PROPOSED GREAT NORTH ROAD SOLAR AND BIODIVERSITY PARK DEVELOPMENT CONSENT ORDER (REF: EN020262)

EXAMINING AUTHORITY'S SECOND WRITTEN QUESTIONS (ExQ2)

RESPONSES OF NATIONAL GAS TRANSMISSION PLC

Appendix 1
NGT Apparatus

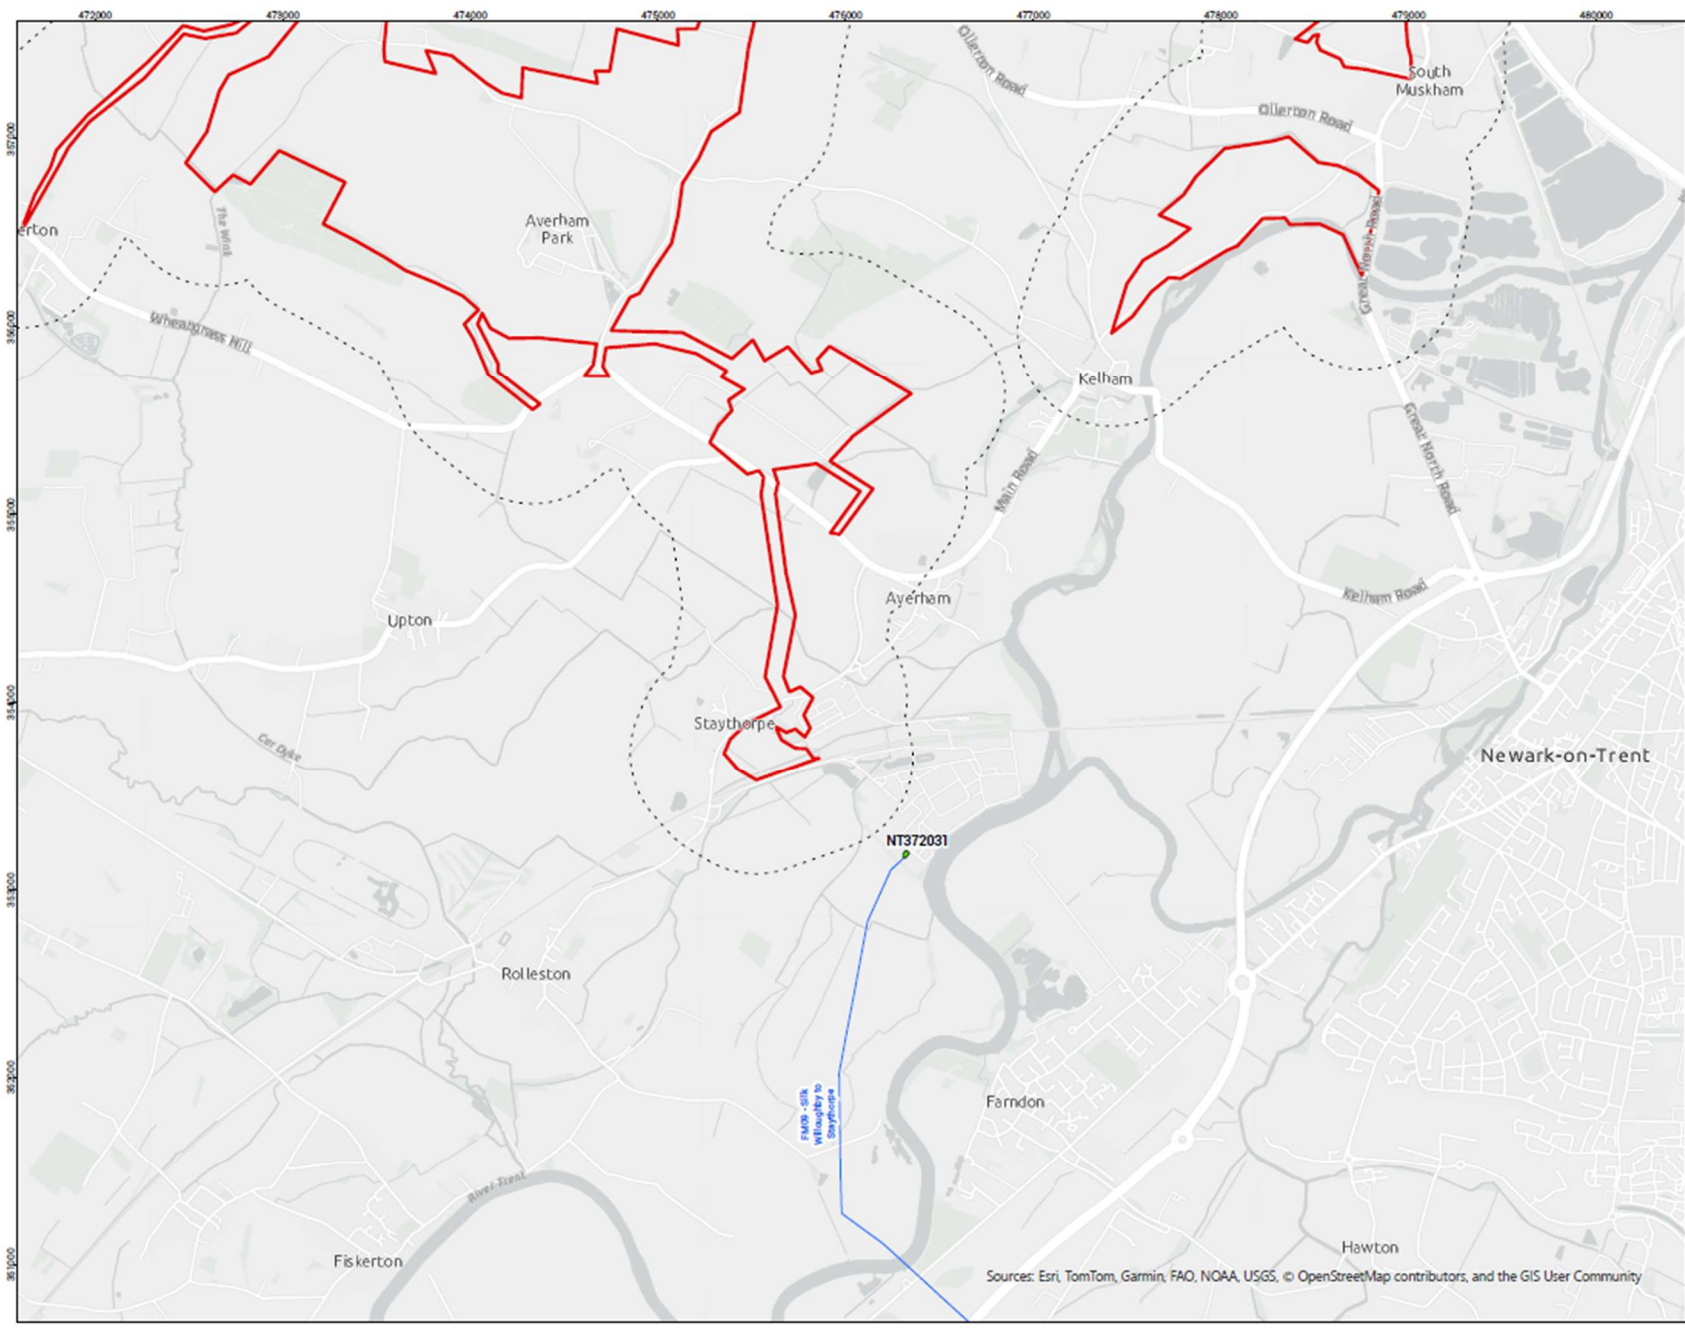
voltages of 66 kV or above should be considered.”, para 6.5) Within this range, there is the potential that in the event of an electrical fault, currents can flow into the ground through a grounding system, causing the surrounding ground to become electrically charged. This current flow causes the ground potential in the vicinity of the fault to rise significantly which can extend several meters away from the point of contact. The magnitude of ground potential rise depends on several factors but the risk increases significantly if pipelines are present due to the potential for the current to be conducted along its length. Pipelines with low resistance to electromagnetic interference are particularly susceptible such interference and there is a risk of electric shock to personnel and equipment working on or in proximity to any such pipeline when a fault occurs.

Although the Applicant has a duty to consider earthing design and electromagnetic interference in the design of its Project, there are a different set of standards for pipelines, as set out in UKOPA/GPG/050 Edition 1 - Electrical Interaction on Pipelines: Collaboration between Developers and Operators, which help ensure compliance to the Pipelines Safety Regulations 1996.

The assessment of these effects is a specialist area, requiring specialist competencies. NGT reserve the right to approval any assessments of such effects on its pipelines.

b. NGT considers that these issues can be resolved at detailed design stage to ensure that Works 6 (connection works to existing substation) and 7 (connection works to consented BESS) are constructed in such a way as to minimise the risk of electromagnetic interference to the NGT apparatus.
